P&Z STAFF REPORT

Board of Appeals Meeting, July 14, 2020

Case: **V20-0001 – 1190 & 1194 Hope Road**
Staff Contact: Madalyn Smith (madalyn.smith@sandyspringsga.gov)
Report Date: June 30, 2020

Case: **V20-0003 – 1625 Sunnybrook Farm Road & 0 & 1220 Tynecastle Way NE**
Staff Contact: Madalyn Smith (msmith@sandyspringsga.gov)
Report Date: January 29, 2020

Conceptual Site Plan for 1190 & 1194 Hope Road. The orange delineates the undisturbed Landscape Buffer and the yellow delineates the Compatible Massing Buffer.

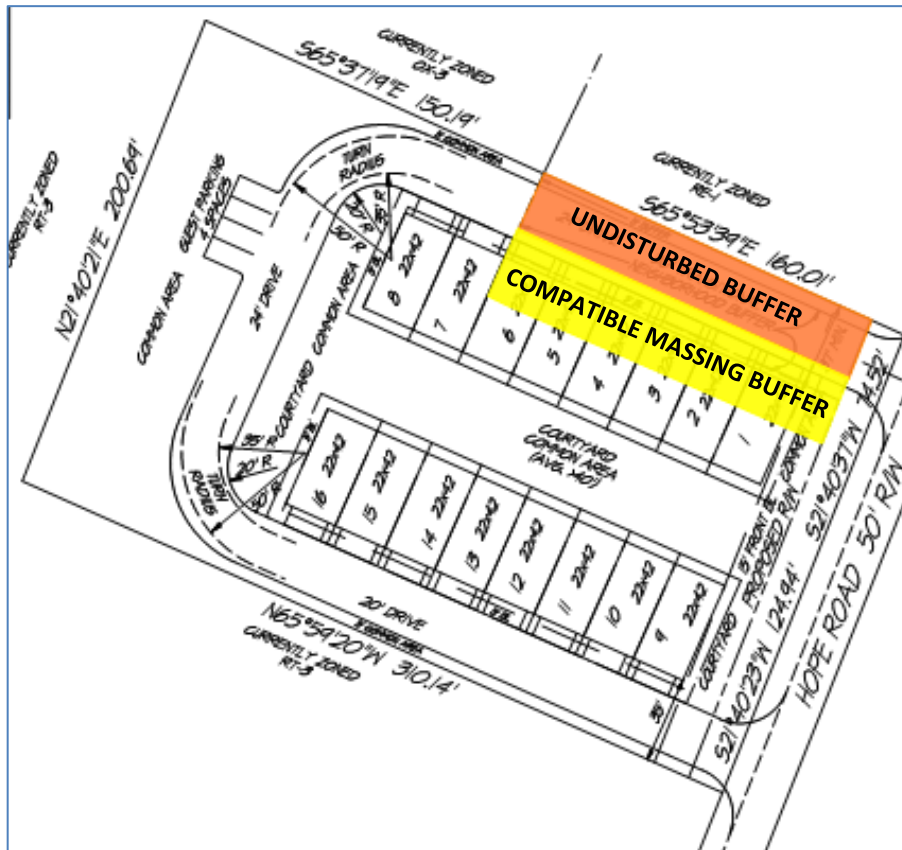
Finding: The application of the full 25-foot Landscape Buffer would require 3,750 square feet of the approximately 62,000-square foot lot to be an undisturbed Landscape Buffer. An additional 30-foot Compatible Massing Buffer restricts the height of development to 28 feet. In total, the Protected Neighborhood transition area is 55 feet in depth and an area of 8,250 square feet.

As seen in the graphic above, the undisturbed buffer would eliminate the alley, preventing half the townhomes in the development from rear access. Even if the applicant eliminated direct access for half the townhomes, the Compatible Massing Buffer would limit the rear half of the townhomes to a height of 24 feet which is not desirable or realistic from a design perspective. The application of the 25-foot undisturbed buffer essentially eliminates half the proposed townhomes and does not allow the applicant to build according to the Development Code's prescription for a "Cottage Court" development pattern. The site is also too narrow to allow the applicant to simply shift the development outside of the transition buffers. For this reason, Staff believes there is a hardship.

Limits of the wetlands area

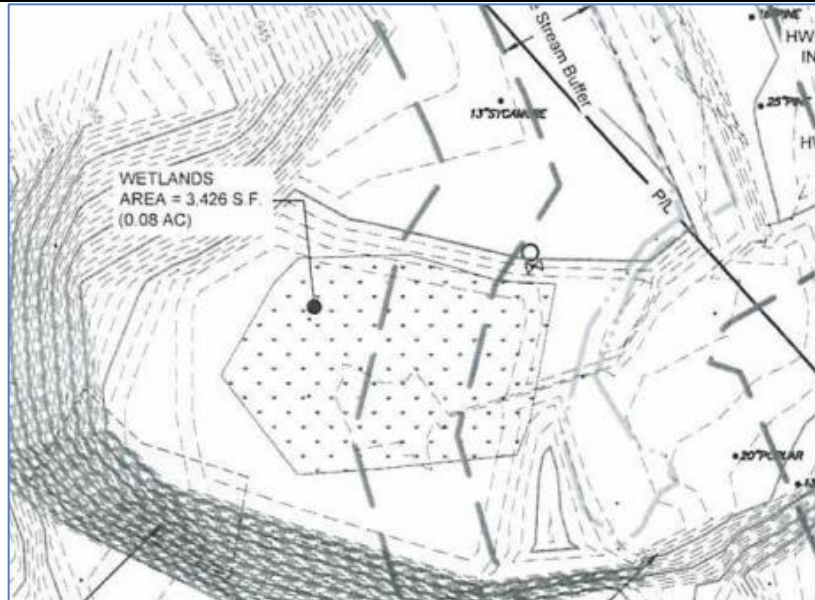
Finding: The 50-foot buffer and 25-foot setback area proposed to be disturbed is currently wooded and sloping. There is also a former quarry area with a sheer cliff. The quarry area has a 3,426-square foot wetland, as identified by the Army Corps of Engineers, which spans the buffer and setback area (see plan below).

ILLUSTRATIVE SITE PLAN

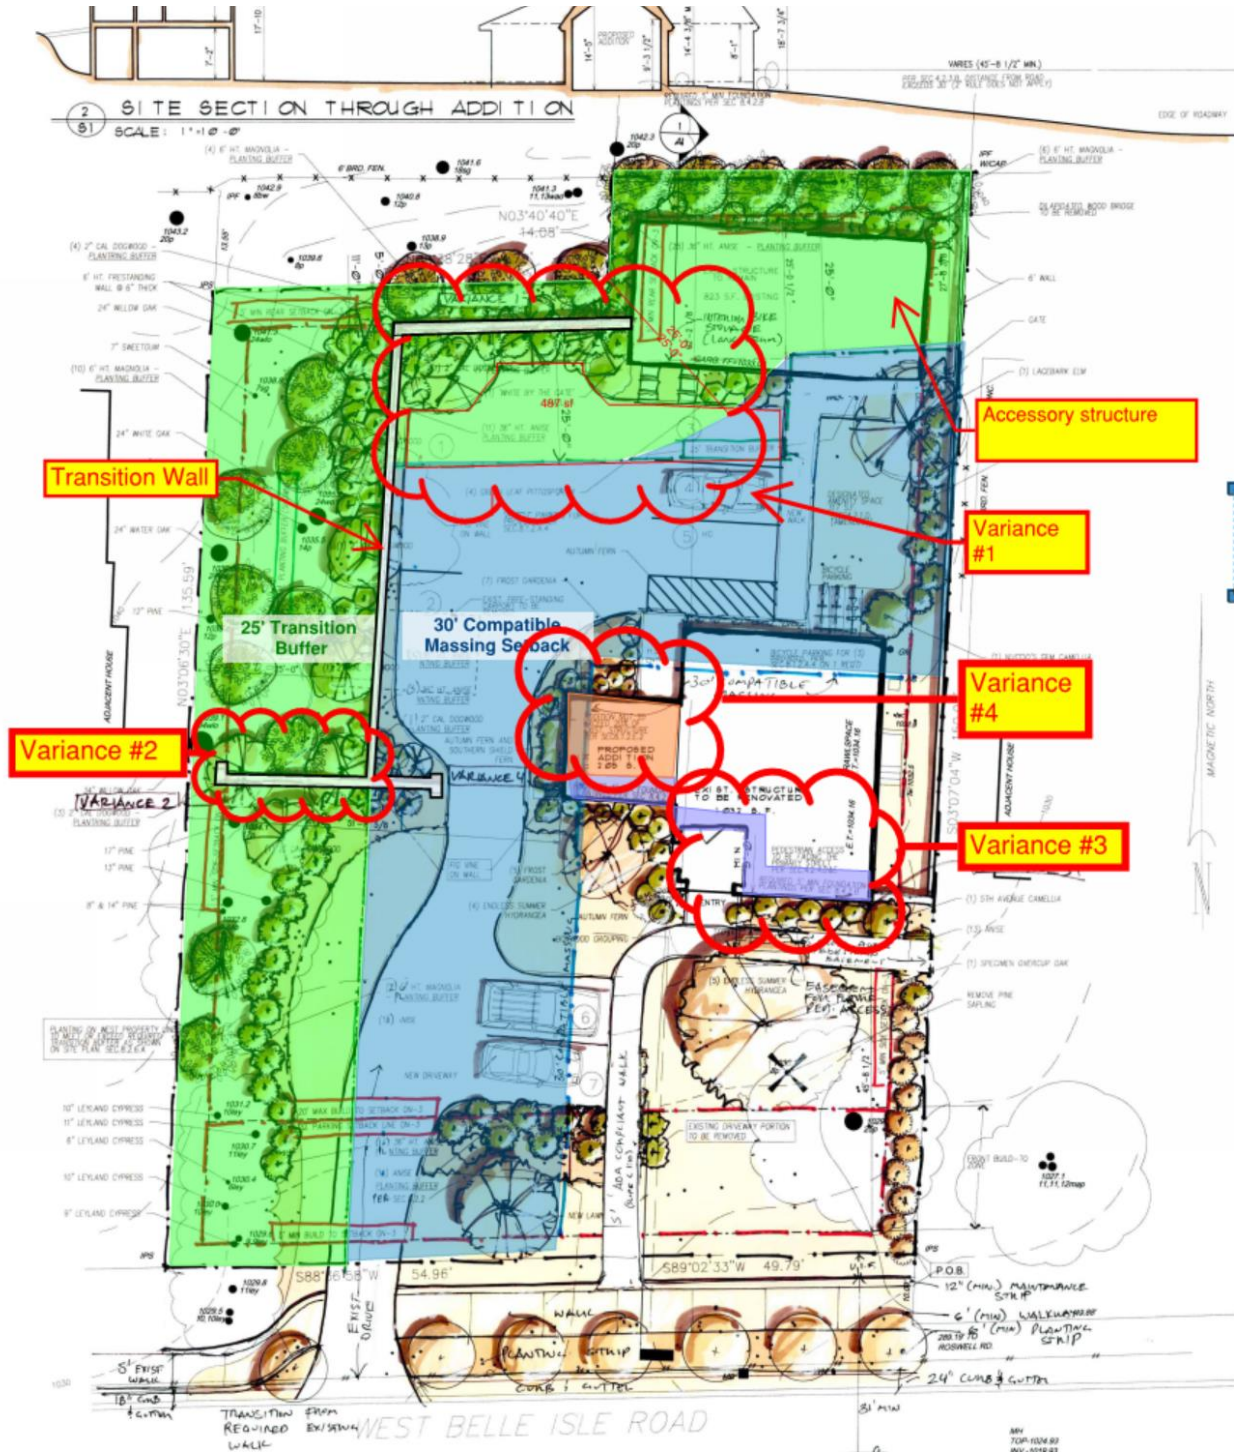
Variance #1.b. from Sec. 6.4.2.1. is a request to allow a 14-foot maximum encroachment into the 25-foot Protected Neighborhood Transition Buffer for the location of a parking space and turnaround area. The applicant seeks to locate the proposed parking space and turnaround area closer to the garage door of the existing accessory structure located to the rear of the property in order to maintain the residential feel of the property and have access to the garage. The proposed encroachment area is approximately 487 square feet as shown on the proposed site plan dated January 11, 2020, received by Staff January 21, 2020.

Variance #1.b.: Regarding the parking and turnaround area encroachments requested by the applicant into the 25-foot Protected Neighborhood Transition Buffer along the rear property line, Staff did not find a hardship nor extraordinary conditions on the site that would justify the parking and turnaround encroachment. However, Staff is of the opinion that minimal encroachment into the required buffer should be considered, conditioned to only the area described as the portion of the property within 25 feet of the rear property line, that is also south and east of the western side of the accessory structure (as illustrated in Exhibit A of this Staff Report). Staff believes this to be the minimal Variance necessary for the reasonable use of and access to the garage door area and the accessory structure in general.

Conditional Approval of Variance #1.b. (amended), request for a Variance from Sec. 6.4.2.1. to encroach into only the alternative area of the Protected Neighborhood Transition Buffer described as the portion of the property within 25 feet of the rear property line that is also south and east of the western side of the accessory structure (as illustrated in Exhibit A of this Staff Report).
